To: T-10/SPI-4 Working Group
From: Richard Moore
QLogic Corp.
Date: August 18, 2000

Subject: SPI-4 Clarifications

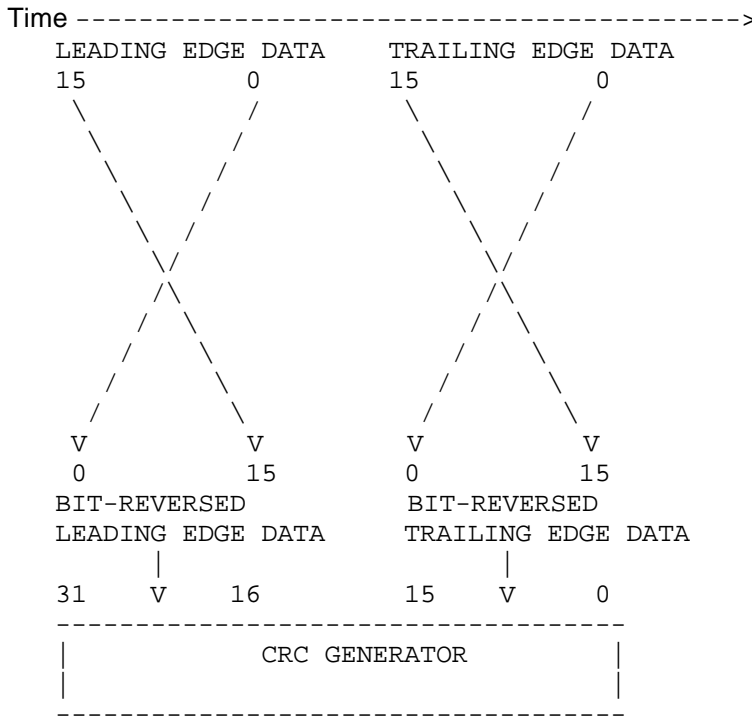
The diagram in Figure 57, and the accompanying text in 11.3.4, are confusing. The figure shows the bytes being re-ordered before the bits are flipped but the text only mentions the bit flipping. Swapping two bytes and then reversing the bits in each byte (as shown in the figure) is equivalent to simply reversing the bits across all 16 bits:

Swapping two bytes B1[7:0], B0[7:0] gives B0[7:0], B1[7:0]
 Reversing bits on each byte then gives B0[0:7], B1[0:7] which is the exact reversal of the original 16 bits.

The figure itself is overly complicated. The figure could be redrawn along the following lines to make it easier to understand:

with similar changes at the output of the CRC generator. The present complex form of this diagram seems to be a result of an earlier version of the CRC proposal which allowed CRC for narrow as well as wide transfers; since CRC is only allowed for wide transfers the narrow representation is not necessary.

The two paragraphs in 11.2.3, beginning with "Bytes are bit reversed...", could be rewritten for greater clarity as follows:

"The data transferred on the leading edge of a REQ or an ACK is bit-reversed and becomes the most significant 16 bits of the CRC generator's input. The data transferred on the trailing edge of a REQ or an ACK is bit-reversed and becomes the least significant 16 bits of the CRC generator's input.

"The most significant 16 bits of the CRC generator's output are bit reversed and the one's complement of this result forms the portion of the CRC field that is transferred on the leading edge of the CRC REQ or ACK. The least significant 16 bits of the CRC generator's output are bit reversed and the one's complement of this result forms the portion of the CRC field that is transferred on the trailing edge of the CRC REQ or ACK."
